Re: MV2021L2-0004: Annual Geotechnical Inspection Report Submission, Prairie Creek Mine, NT

Subject: 2024 Annual Geotechnical Inspection of Flood Protection Works and Rock Piles
Prairie Creek Mine, Northwest Territories

Photo 1

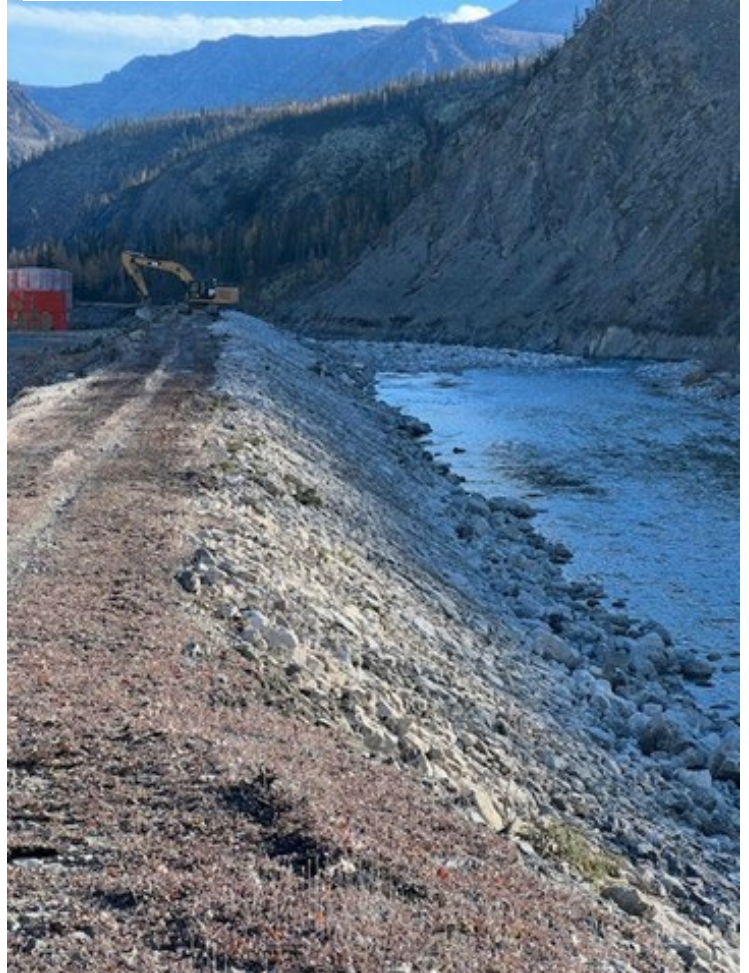
- Repair and regrade the creek side slope of the berm between Monitoring Sites NHC-02 and NHC-05, where erosion and oversteepening have occurred, to a slope gradient of 1.5H:1V or flatter. It is recommended that any suitable riprap along the upper bank of the berm be removed and reused after correcting the slope;

- Repair and regrade of the creek side slope of the berm between Monitoring Sites NHC-02 and NHC-05 was completed in 2024 in areas where erosion and oversteepening was identified.

Flood Protection Berm repair and regrade work between Monitoring Sites NHC-02 and NHC-05, 2024.

2024 ANNUAL GEOTECHNICAL INSPECTION PRAIRIE CREEK MINE, NORTHWEST TERRITORIES					
WATER STORAGE POND PLAN					
PROJECT NO. ENG.EARC03183-06		DWN EL	CKD TB	REV IFU	FIGURE 3
OFFICE EDMONTON		DATE NOVEMBER 2024

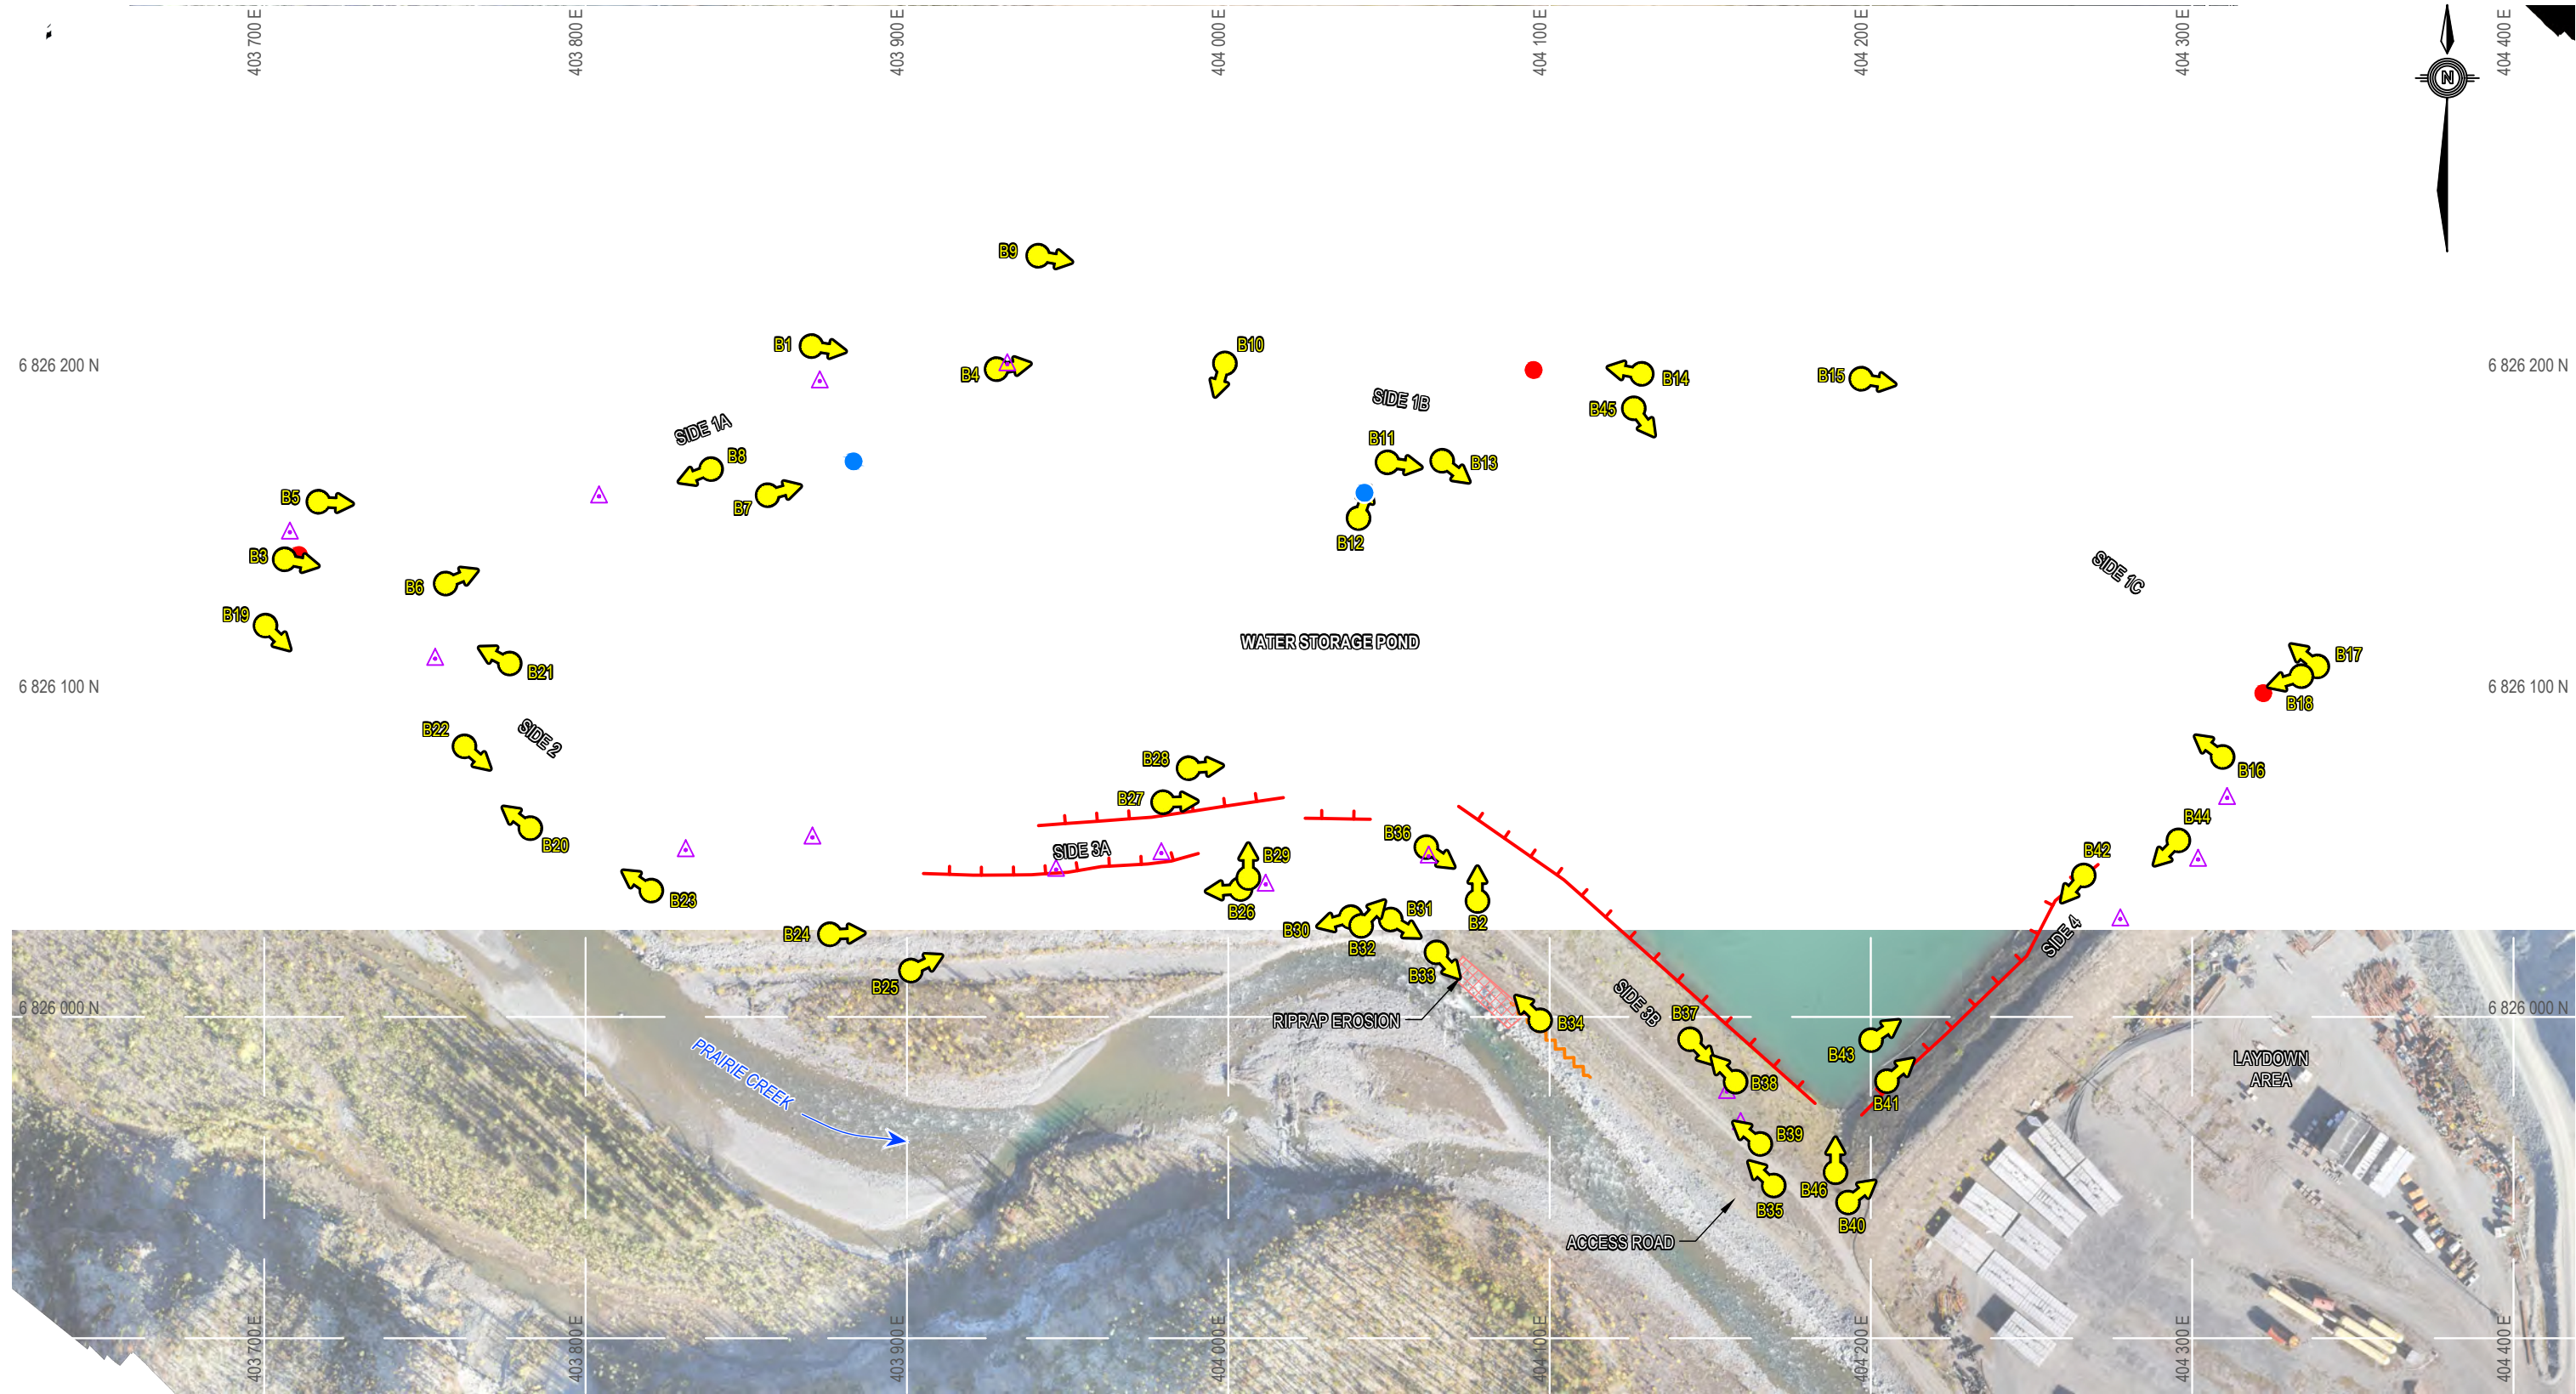
- Repair and regrade the creek side slopes of Side 3B, where erosion and oversteepening have occurred, to a slope gradient of 2H:1V or flatter
 - CZN will repair and regrade the creek side slopes of Side 3B in 2025 when riprap material becomes available.

- CZN will repair the creek side slopes of Sides 2, 3A, and 3B with existing riprap in 2025.
- Remediate the existing rapid drawdown failure scarps that have occurred on the pond side slopes of Sides 3A, 3B, and 4

- CZN will remediate the failure scarps that have occurred on the pond side slopes of Sides 3A, 3B, and 4 with existing riprap in 2025.
- Repair cracking in the road at the crest of Side 1B by grading, adding fill, or other methods to prevent loss of utility

- CZN will repair the cracking in the road at the crest of Side 1B with existing riprap in 2025.
- Repair damage to clay core of embankments caused by animal burrows.
